INDESIT company

Model type:
IDL50EU.2

Commercial code:
F032006

Notices

N1045072FIG1

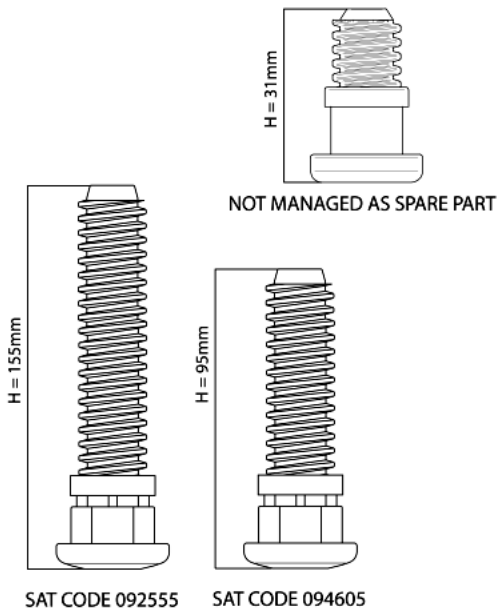
N1045072: Introduction of fixed rear foot H=31mm on free-standing models.

From serial no. 40218.0001, free-standing dishwashers affected by this modification have been equipped with new fixed rear feet (H=31mm).
The new foot replaces the adjustable one (H=155mm) Service code 092555; on the EVO3 range with TurboDry the new foot replaces the adjustable foot (H=95mm) Service code 094605.
The Spare Part Warehouse will continue to manage only 155mm and 95mm adjustable feet as they are interchangeable with the fixed 31mm foot.
The three feet are shown in illustration N1045072FIG1.

N1045083FIG1

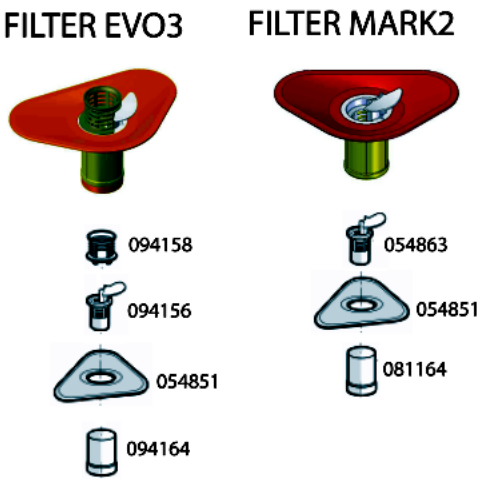
n1045083: Modification of filters on EVO3 60 cm dishwashers

All dishwasher models affected by this modification have been equipped with the items listed below, in order to solve the drain pump clooging problem.

Introduction of:
Cylindrical plastic filter code 081164
Central filter code 054863

Elimination of:
Cylindrical plastic filter code 094164
Central filter code 094156
Central filter grid code 094158

The modification has been introduced progressively, starting from serial no. 40516.0001.

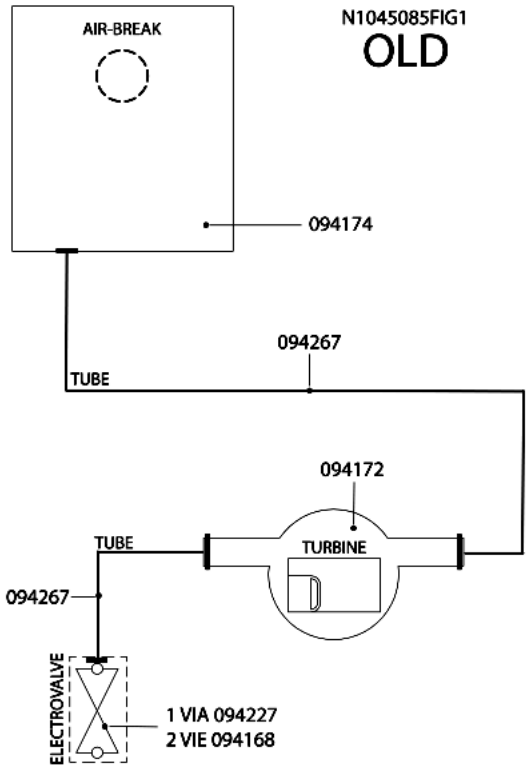
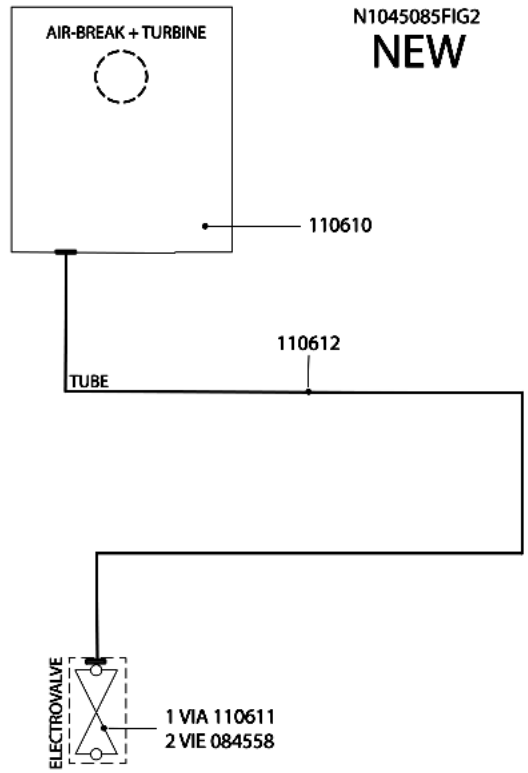
n1045085: Introduction of new litre counter turbine integrated on air-break.

All dishwashers affected by this note have been equipped with a new litre counter turbine on the air-break.
Picture N1045085FIG1 illustrates the premodification structure, picture N1045085FIG2 the new structure.

Items affected by the modification.

AIR-BREAK:
new 110610;
premodification 094174;
the new item features a new integrated litre counter turbine and its water supply hose has a smaller diameter.

LITRE COUNTER TURBINE code 094172 has been eliminated.

SOLENOID VALVES:
new:
1-WAY code 110611;

2-WAY code 084558(Rohs 143737);
premodification:
1-WAY code 094227;
2-WAY code 094168;
the new solenoid valves have a smaller diameter drain hose fitting.

HOSES:
new solenoid valve hose/air-break code 110612;
premodification turbine hose/air-break code 094267;
premodification solenoid valve hose/air-break code 094267;
the new hose has a smaller internal diameter.

WIRING:
the litre counter turbine connecting cable is longer, but since the connector is the same, the new item can be used in place of the premodification one.

N1045133/134FIG1

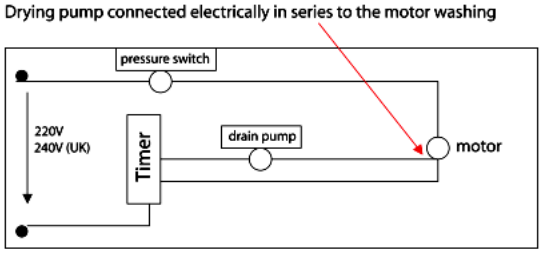
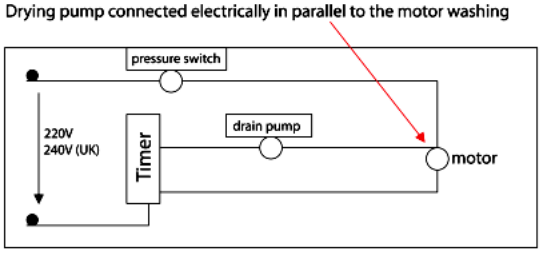
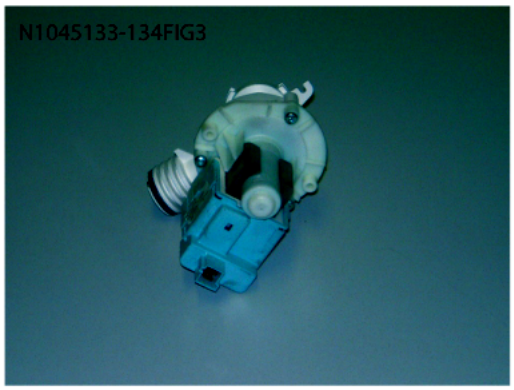
n1045133: New thermoprotected drain pump in parallel with wash electric pump

The drain pump electrical connection has been modified from a configuration in series with the wash electric pump to one in parallel.

The drain pump in series with the wash electric pump is fed through the wash electric pump causing a voltage drop equal to -15V (diagram N1045133-134FIG1).

The drain pump in series with the wash electric pump is electrically fed directly by the F-N line, without any voltage drop (diagram N1045133-134FIG1).

New parts:
Wiring in parallel
C00118767(Rohs 143766) - thermoprotected drain pump 220/240V 50HZ 26W - picture (N1045133-134FIG3)

Premodification parts:
Wiring in series

C00112306(Rohs 143739) - drain pump 230V 50HZ 22W - picture (N1045133-134FIG4)

Important!!
The thermoprotected drain pump cannot be installed on premodification dishwashers.
The non-thermoprotected drain pump cannot be installed on modified dishwashers.

N1045136FIG1

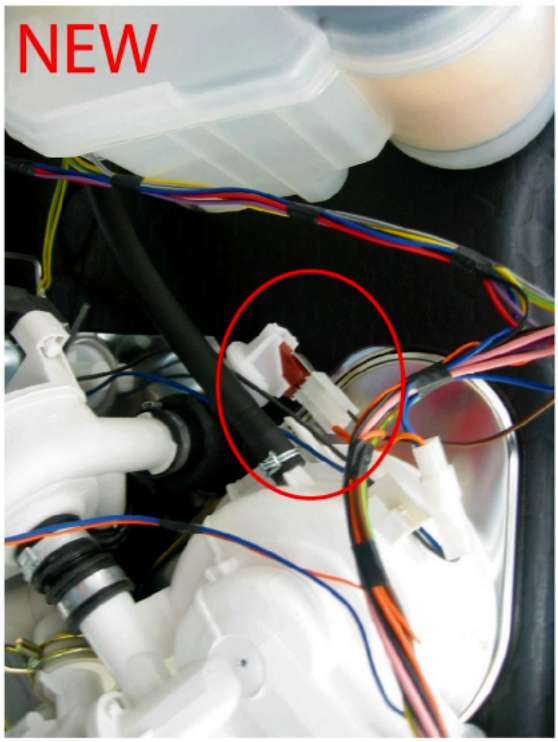
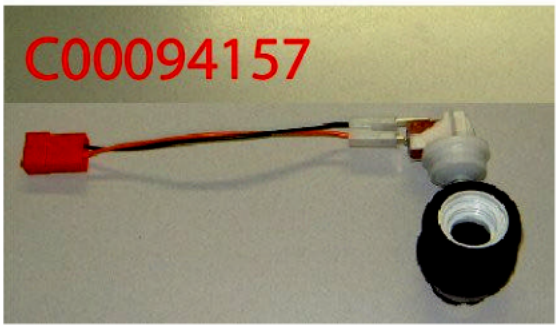
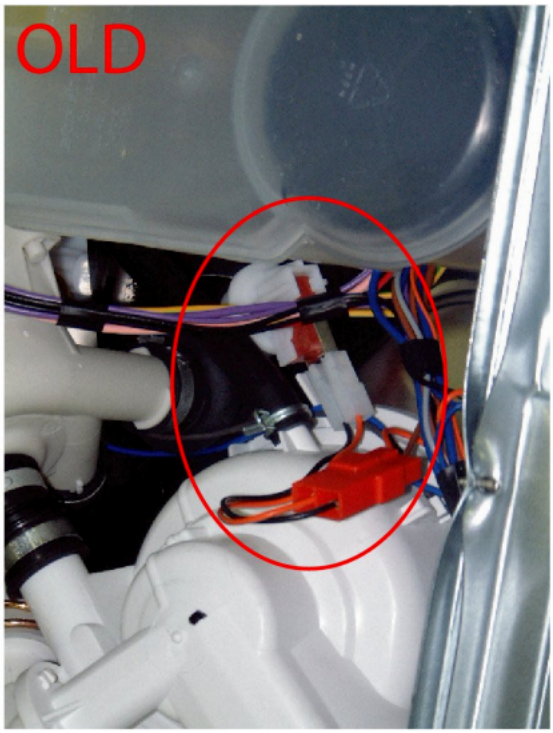
n1045136: introduction of new high pressure sensor

In modified products the connector going to the high pressure sensor is part of the wiring assembly (see picture N1045136FIG1).
In premodification products the high pressure sensor is connected to the wiring assembly by a cable that is part of code C00094157 (see pictures N1045136FIG2-3).

New parts
Wiring
C00142435 - high pressure sensor

Premodification parts
Wiring
C00094157 - high pressure sensor + cable

The new parts are not individually interchangeable with premodification ones.
